REV. DETAILS
B
A
Basement amendments due to Council's R.F.I.
Section 4.56 Modification Application

PROJECT ADDRESS
**78, 80 & 84 Bursill St,
Guildford, NSW, 2161**
PROJECT NO. STATUS
17/14 S.96
DRAWN BY CHECKED BY

DRAWING:
Basement Floor Plan
SCALE: 1:100@A1
1:200@A3
DRAWING NO.: **A2.2**
ISSUE: **B**
Copyright Mackenzie Architects International. All rights reserved

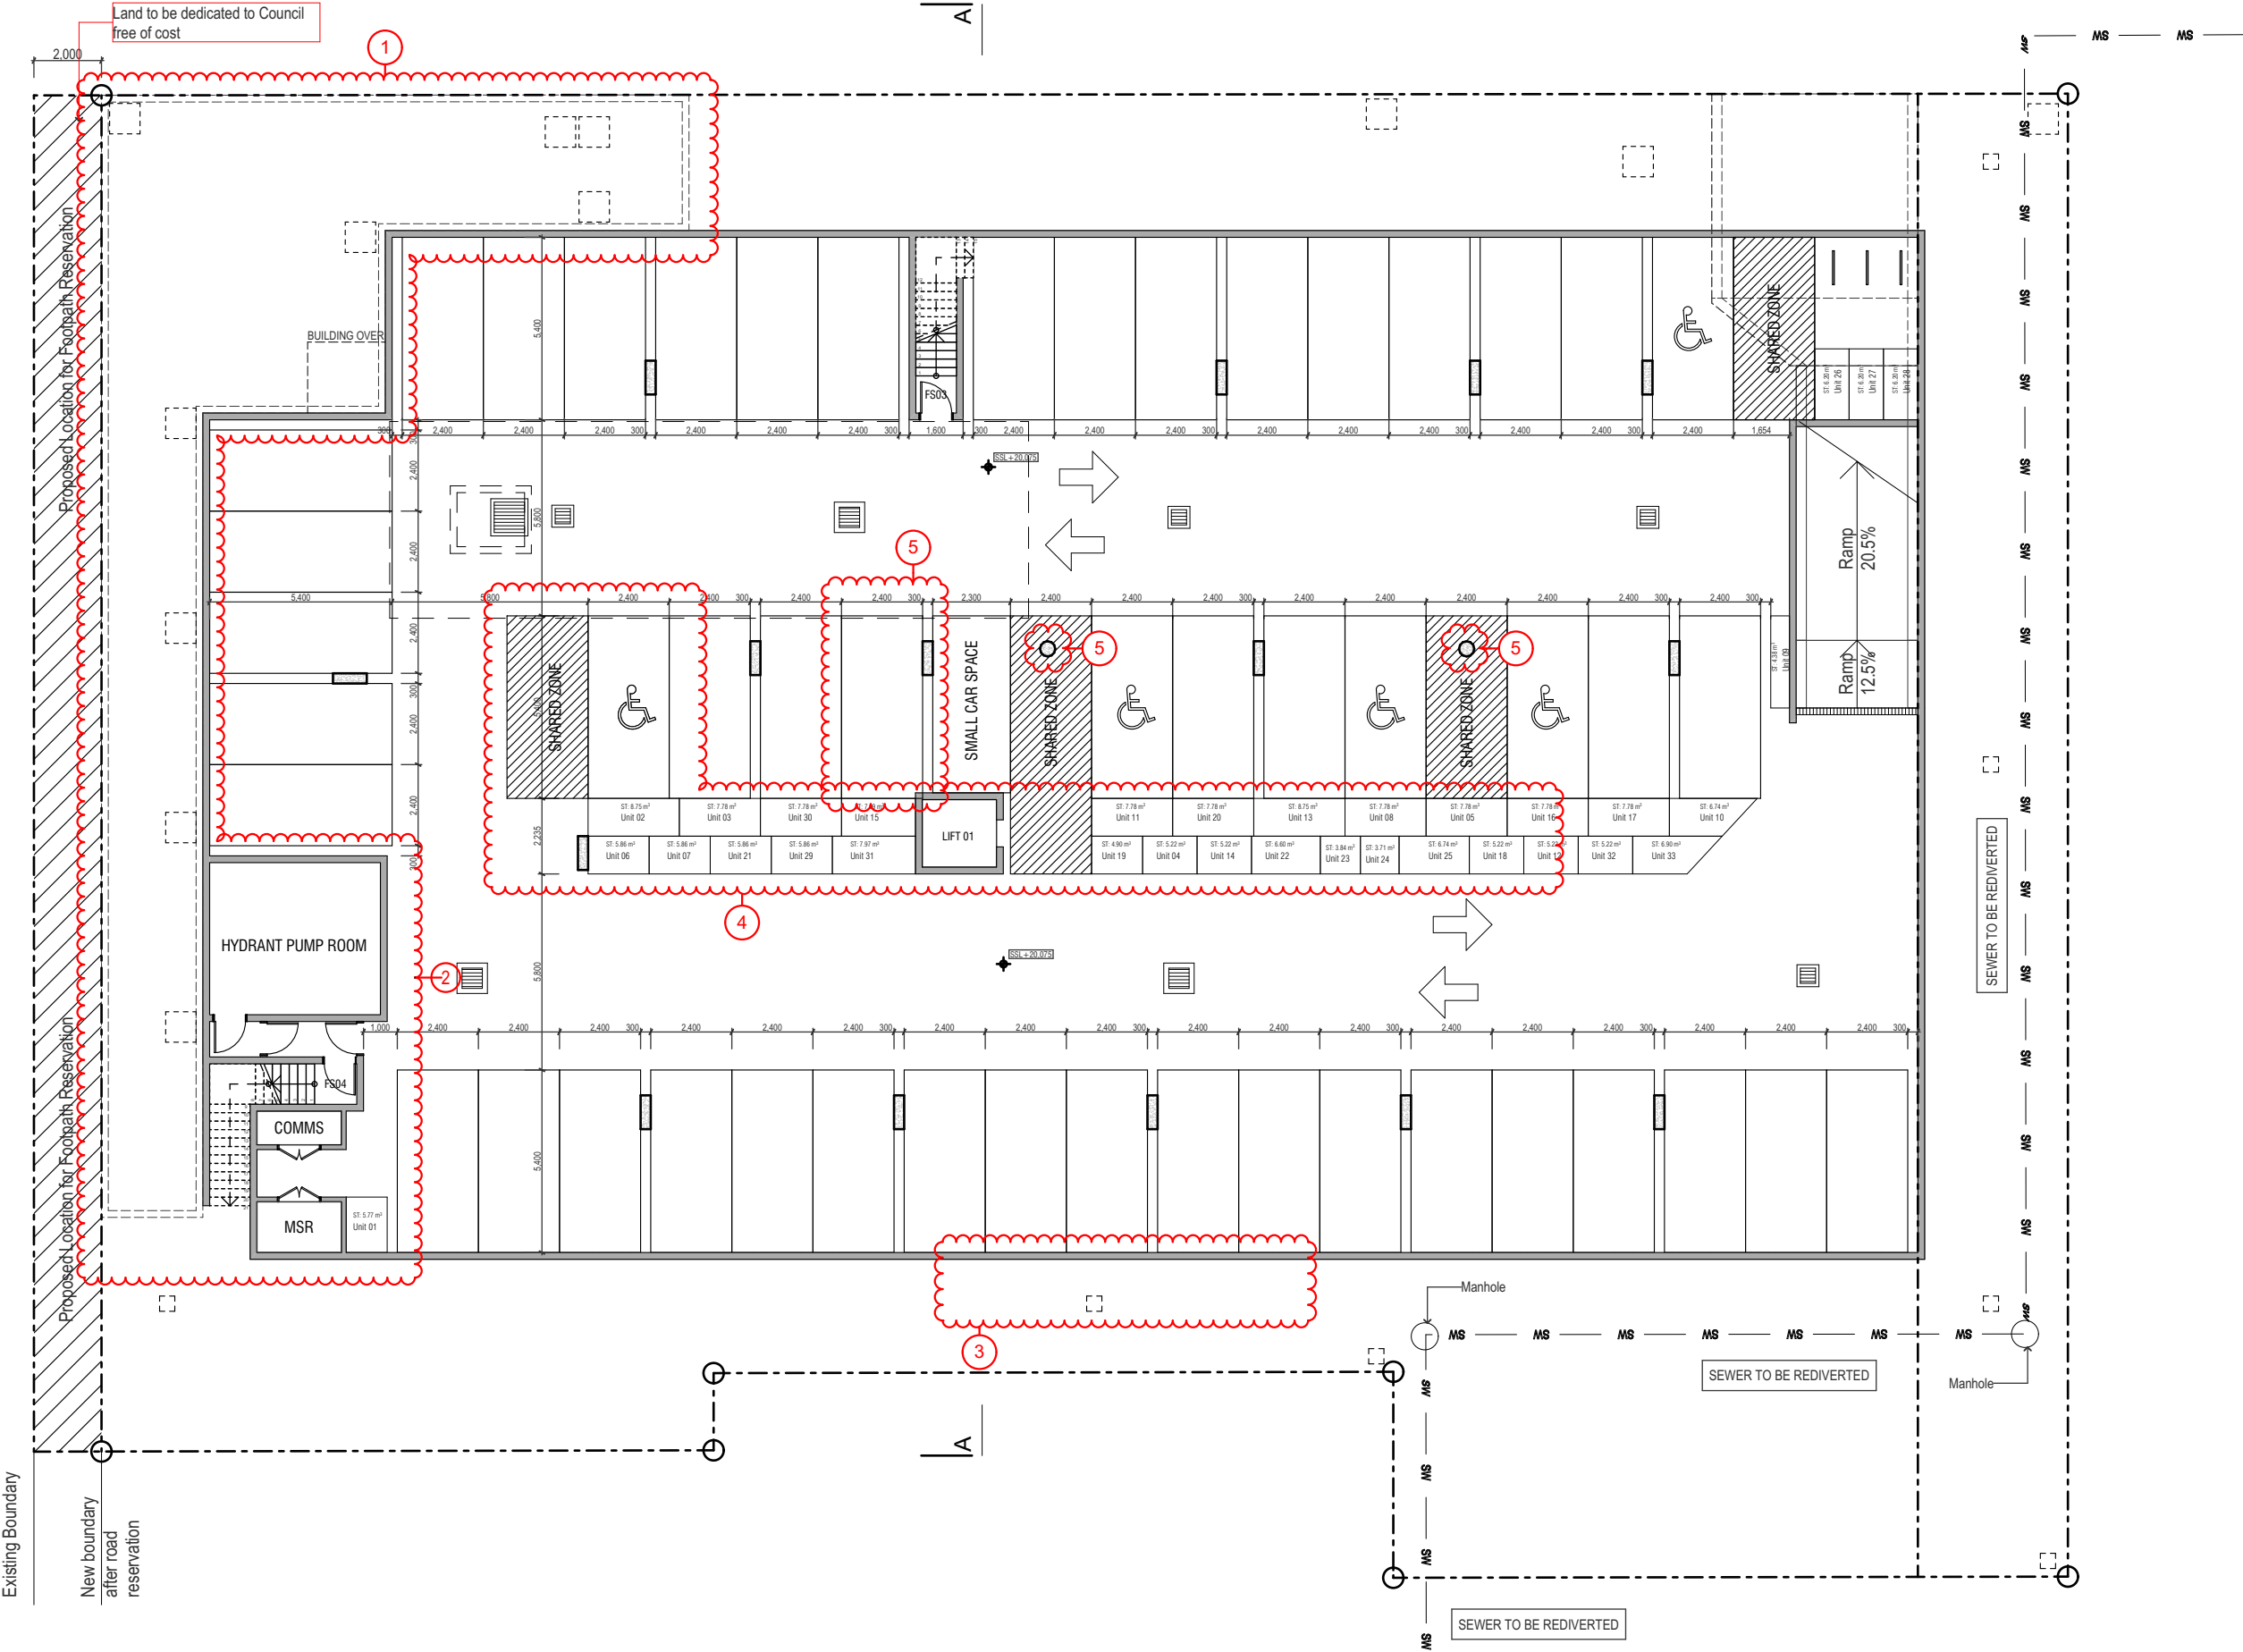
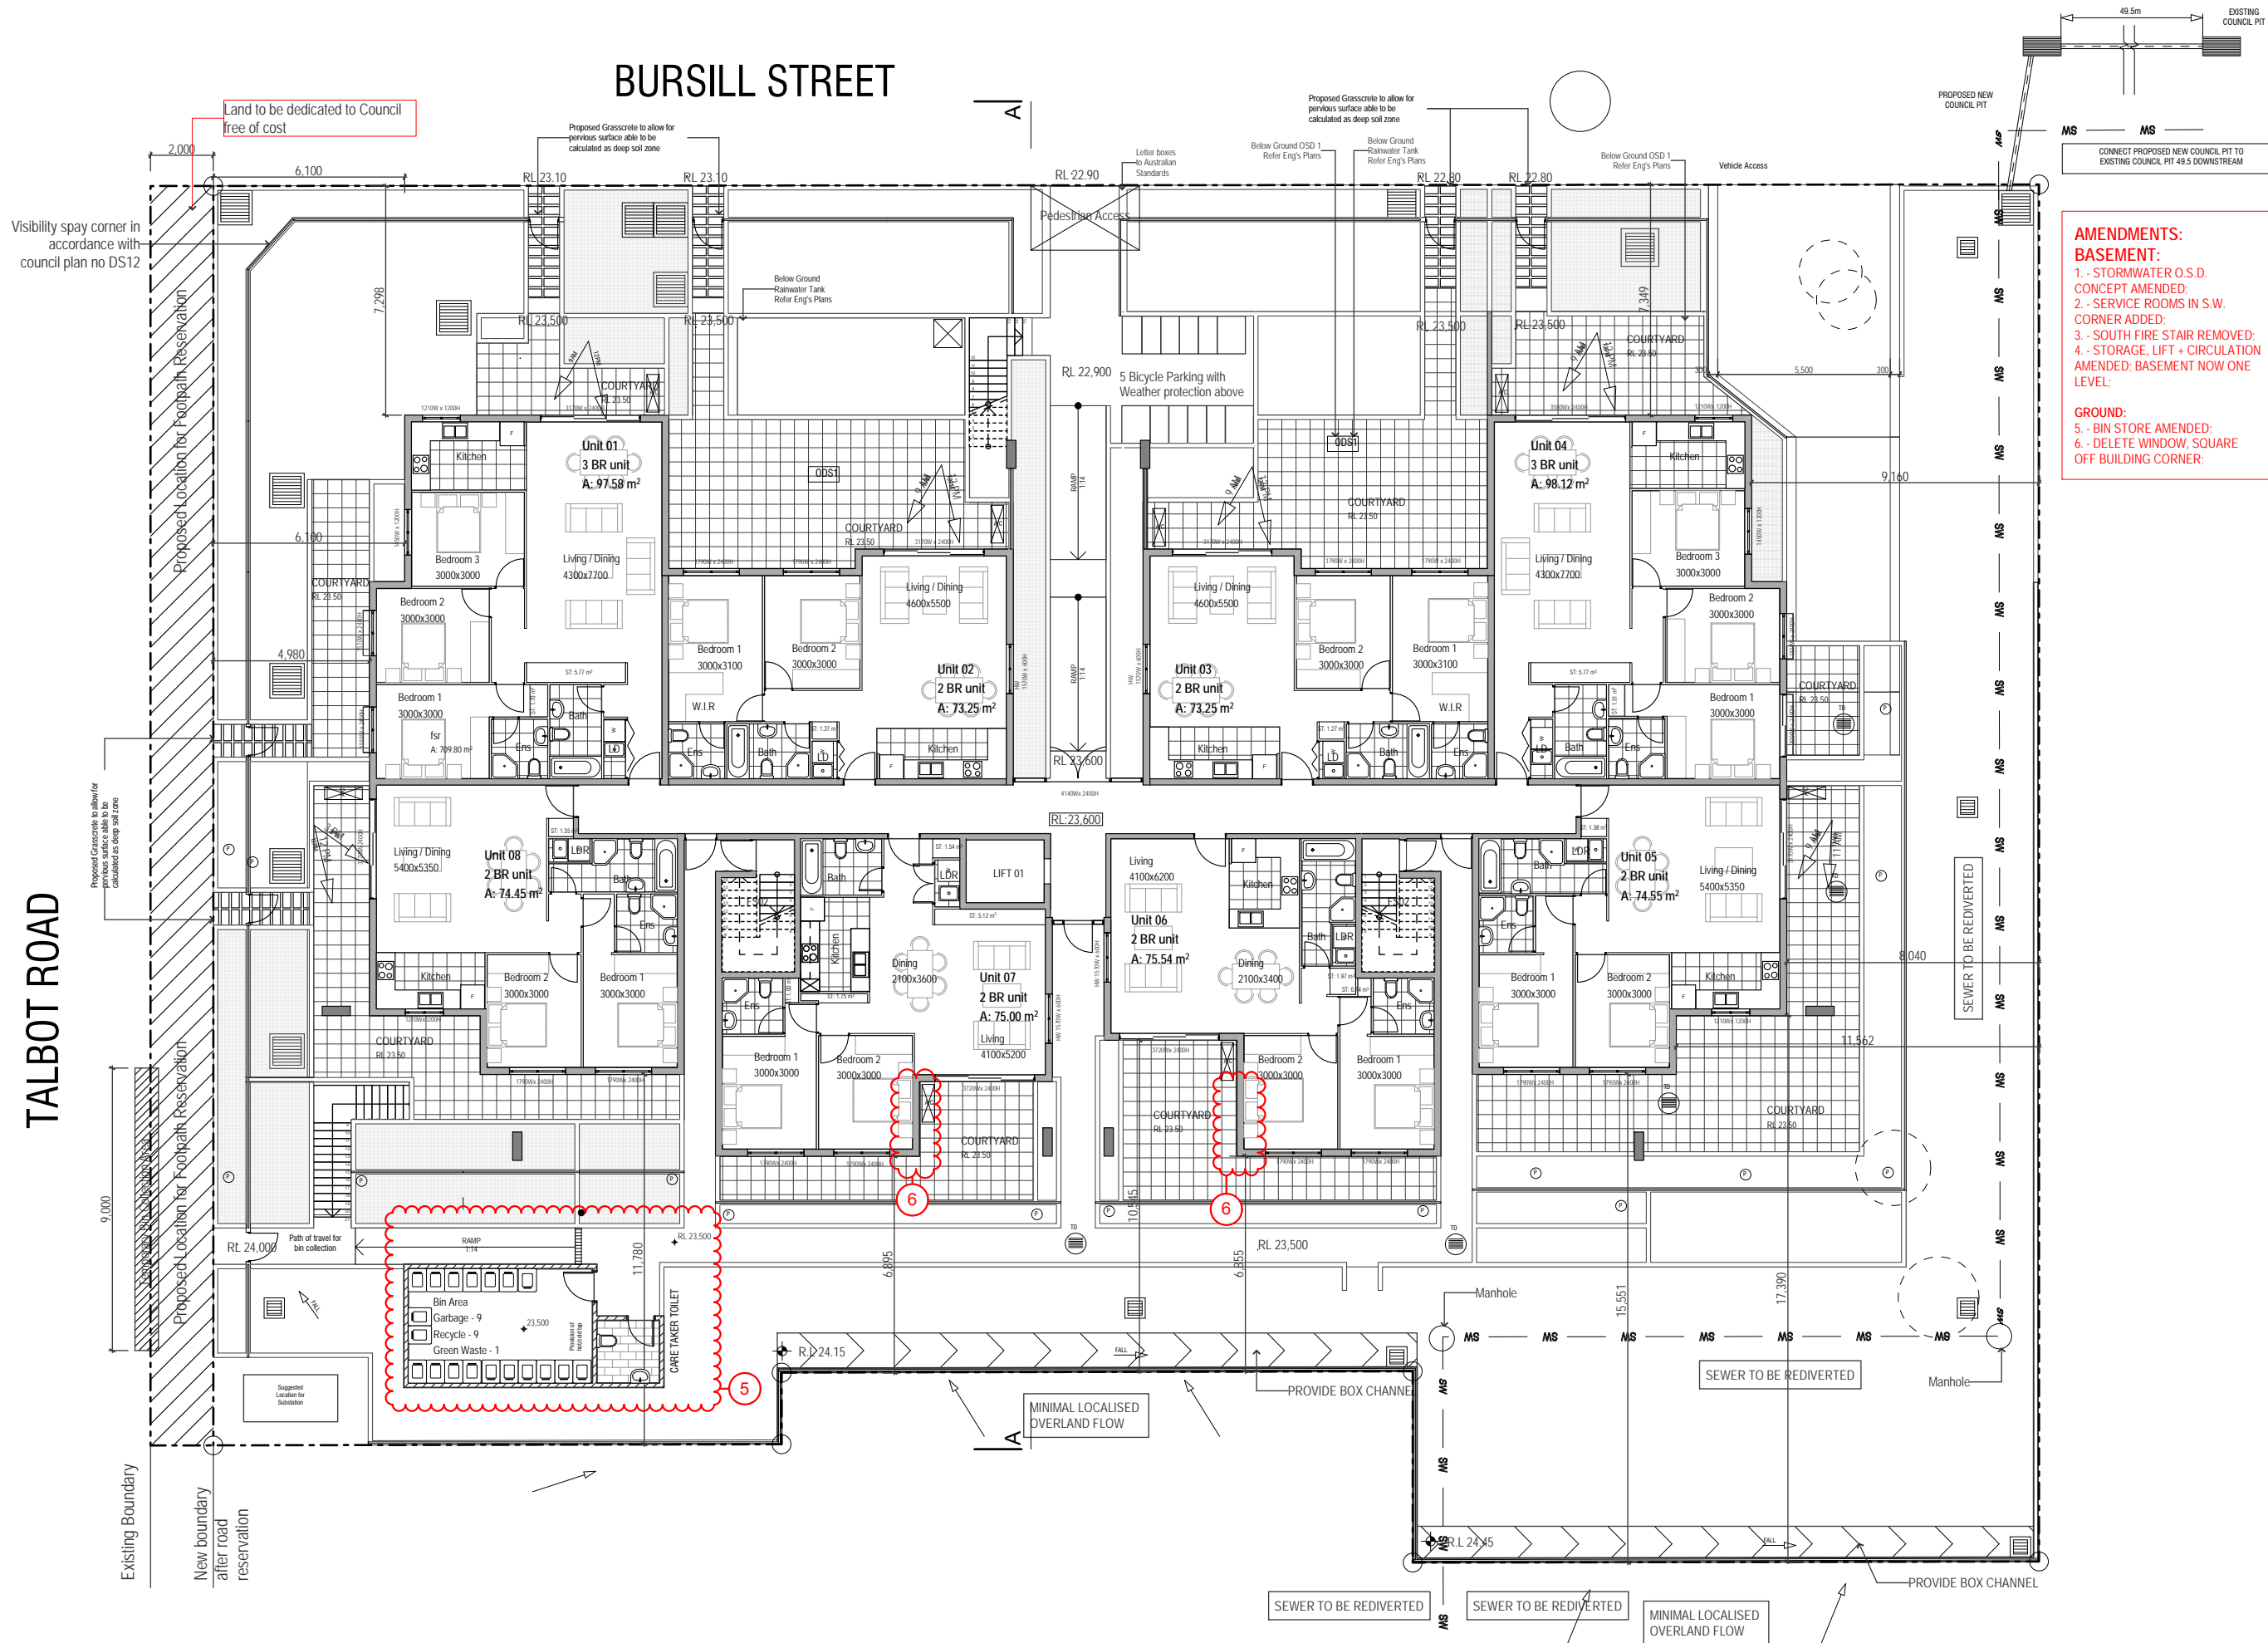
- AMENDMENTS:**
- BASEMENT:**
1. - STORMWATER O.S.D. CONCEPT AMENDED;
 2. - SERVICE ROOMS IN S.W. CORNER ADDED;
 3. - SOUTH FIRE STAIR REMOVED;
 4. - STORAGE, LIFT + CIRCULATION AMENDED; BASEMENT NOW ONE LEVEL;
 5. - SMALL CAR SPACE REPLACED WITH STANDARD DIMENSION CAR SPACE; STRUCTURAL COLUMNS IN SHARED ZONES NOW CYLINDRICAL TO ALLOW ACCESS UNLOADING;

DRAWING:
First Floor Plan

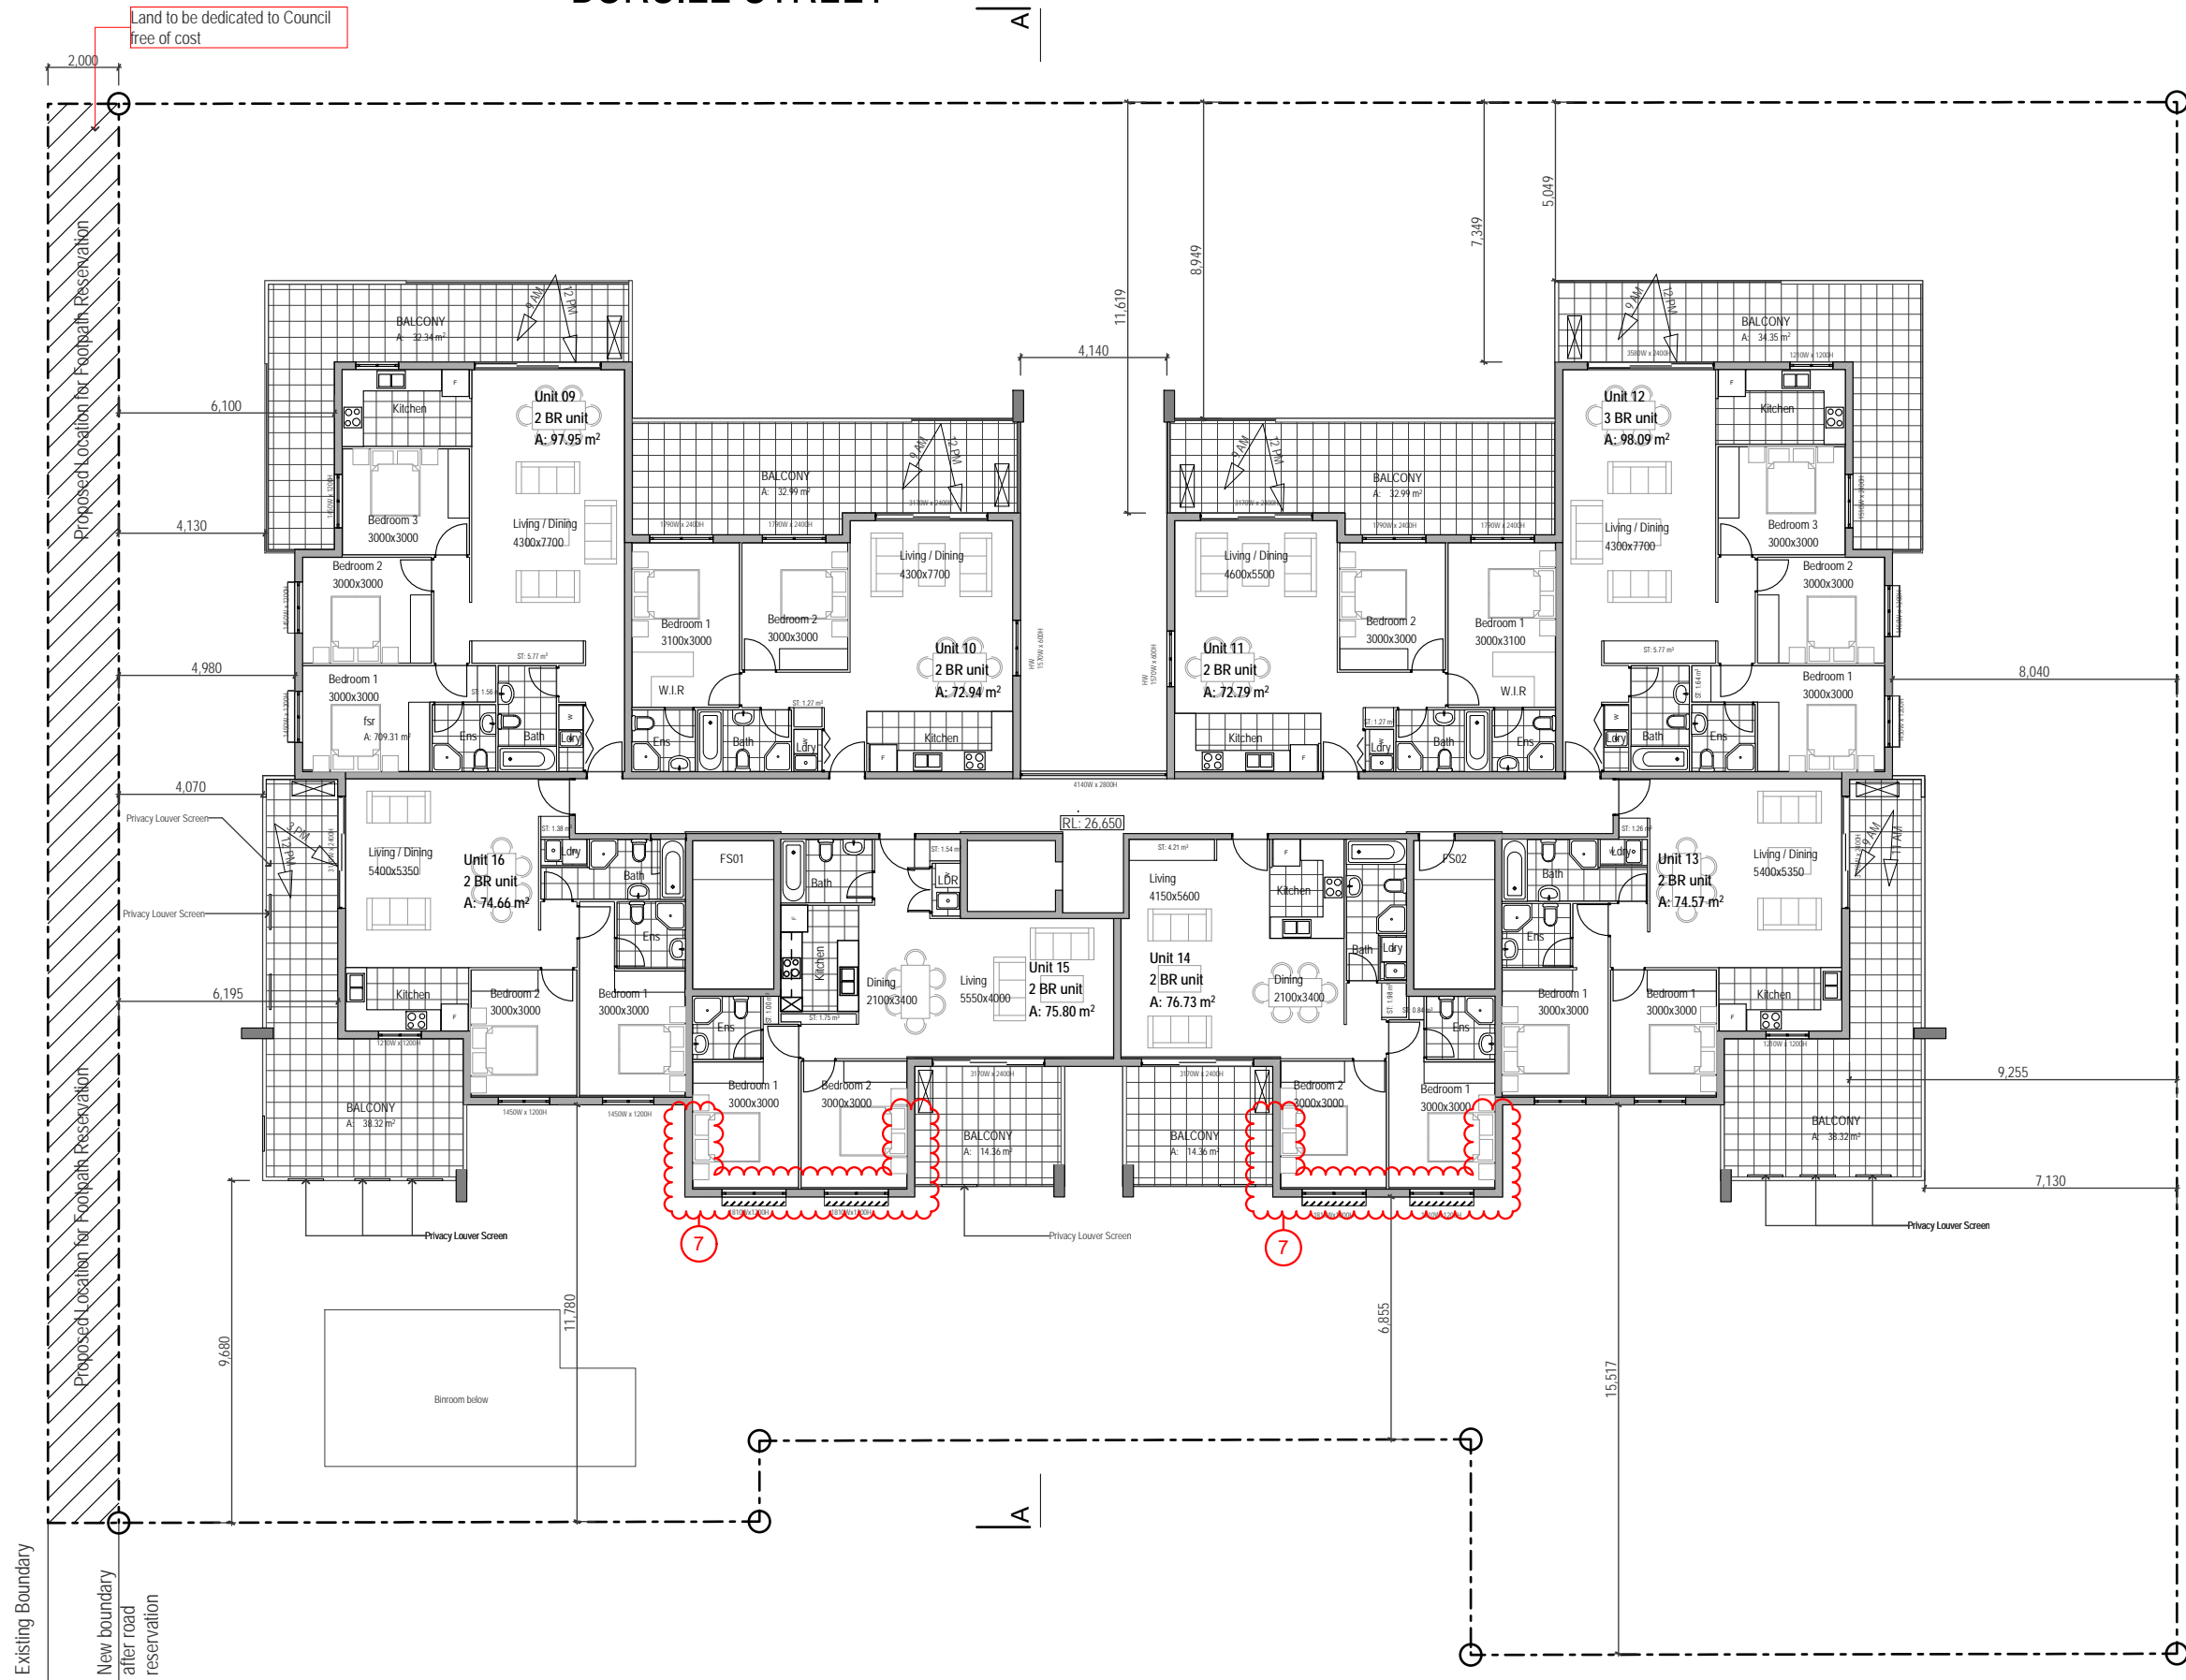
AMENDMENTS:

BASEMENT:

1. - STORMWATER O.S.D.
2. - SERVICE ROOMS IN S.W. CORNER ADDED:
3. - SOUTH FIRE STAIR REMOVED:
4. - STORAGE, LIFT + CIRCULATION

GROUND:

5. - BIN STORE AMENDED:
6. - DELETE WINDOW, SQUARE OFF BUILDING CORNER:

FIRST; SECOND; THIRD:

7. - DELETE BEDROOM 1 WINDOW, MOVE BEDROOM 2 WINDOW, SQUARE OFF BUILDING CORNER:
